TECHNICAL SERVICE BULLETIN

Technical Service Bulletin: 501-1333

TECHNICAL SERVICE BULLETIN 501-1333 REMEDY INSTRUCTIONS

Make(s): ALTA TRAVEL TRAILERS Model(s): MANY, SEE BELOW Model Year(s): 2021	Repair Code: SB-386-22-00-004059 Allotted Time: .50 HRS Inspection Code: N/A Allotted Time: N/A
	Concern: The solar panels are incorrectly wired to the solar panel controller then to the house battery, which can cause the battery to be overcharged.	Photo(s) Required: YES Prior Authorization Required: NO Part(s) Number: N/A Part(s) Return: NO

FIGURE 4

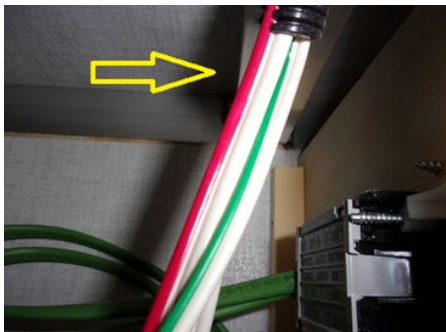
STEP 5: THE WHITE WIRE WILL THEN BE SPLIT FROM THE RED AND WHITE WIRE AND FED BACK THROUGH THE DOCKING STATION TO THE SOLAR CONTROLLER (FIG.4);
